**Validation report form for post-registration changes for
CDM project activities
(Version 03.0)**

Title and UNFCCC reference number of the project activity	Landfill Gas Recovery and Utilization at Bukit Tagar Sanitary Landfill, Hulu Selangor in Malaysia (UNFCCC reference number 2467)
Process track	<input checked="" type="checkbox"/> Prior approval <input type="checkbox"/> Issuance <input type="checkbox"/> Renewal of crediting period
Version number of the validation report	1.2
Completion date of the validation report	29/01/2020
Type(s) of PRCs	<input type="checkbox"/> Temporary deviations from the registered monitoring plan, applied methodologies, standardized baselines or other methodological regulatory documents ¹ <input type="checkbox"/> Corrections <input type="checkbox"/> Changes to the start date of the crediting period <input type="checkbox"/> Inclusion of a monitoring plan <input checked="" type="checkbox"/> Permanent changes to the registered monitoring plan, or permanent deviation of monitoring from the applied methodologies, standardized baselines or other methodological regulatory documents <input checked="" type="checkbox"/> Changes to the project design <input type="

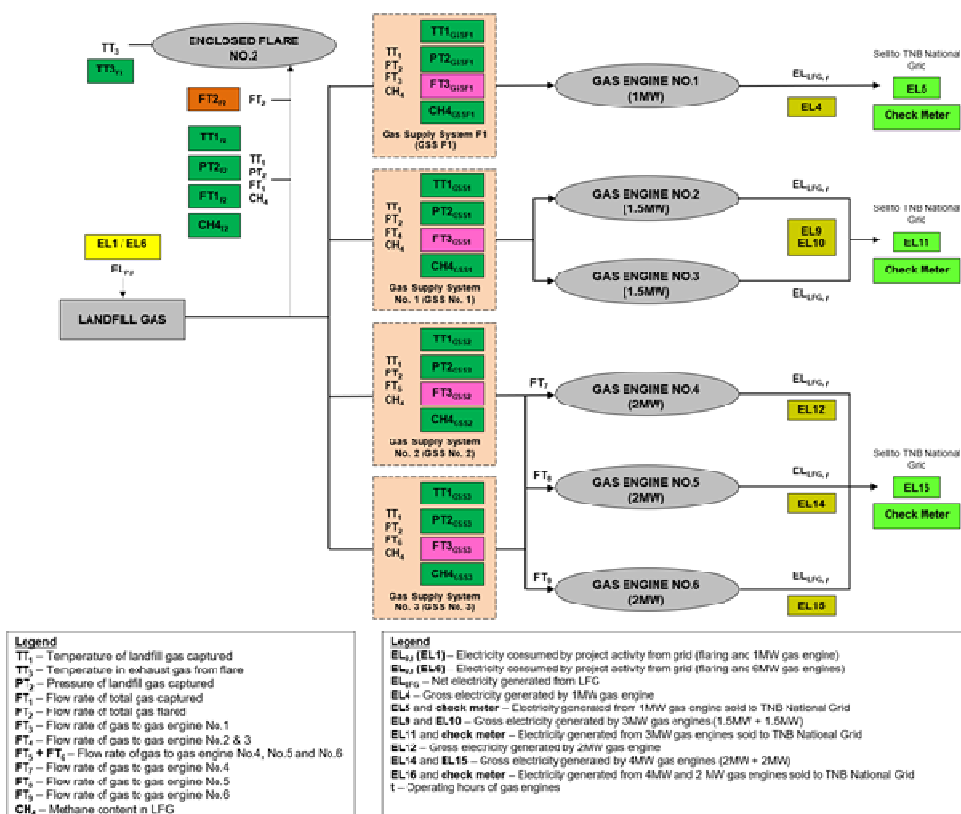
5. Monitoring diagram change

The gross electricity generated by each gas engines are monitored using EL4, EL9, EL10 and EL12. The amount will be compared with EL5, EL11 and EL13 which are managed by Tenaga National Berhad to obtain the lower amount so that the result is conservative.

As data will be captured separately in the flaring and power generation system (Flare No.2, Gas Engine No.1 and so forth), a specific subscript will be assigned to the monitoring parameters of the different equipment installed.

The changes of monitoring diagram mainly take place in the monitoring of electricity and gas flow. The changed monitoring system has been verified by the assessment team during site visit. The monitoring system has been confirmed by the assessment team against the monitoring diagram /9/ to be in consistent with actual situation and is operational. The information of the added meters, such as installation place, accuracy, calibration status etc. has been verified by the assessment team against the specifications of monitoring equipments /7//8/ and via site tour, which is in compliance with monitoring methodology and applicable calibration requirements. Therefore, the assessment team could confirm that the changes do not reduce the level of accuracy of the monitoring compared with the requirements contained in the registered monitoring plan, and do not lead to a reduction in the accuracy of the calculation of GHG emission reductions.
